ADDENDUM NO. 2

RE: City of Queen City, Texas-Earthwork and Drainage Improvements

ADDENDUM DATE: October 11, 2023

CONSTRUCTION ENTRANCE

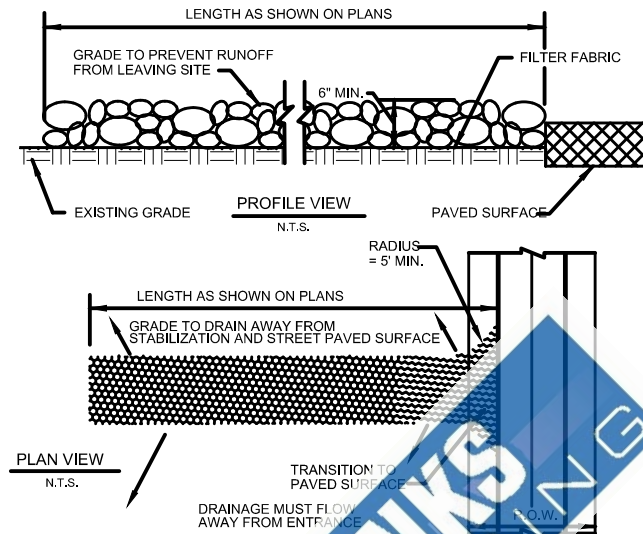
2. **Bid Form:** Bid Item #7 has been added to include a construction entrance/exit. A detail is included of this scope. The contractor shall keep the existing asphalt street clean of sediment during construction by sweeping or other approved methods.
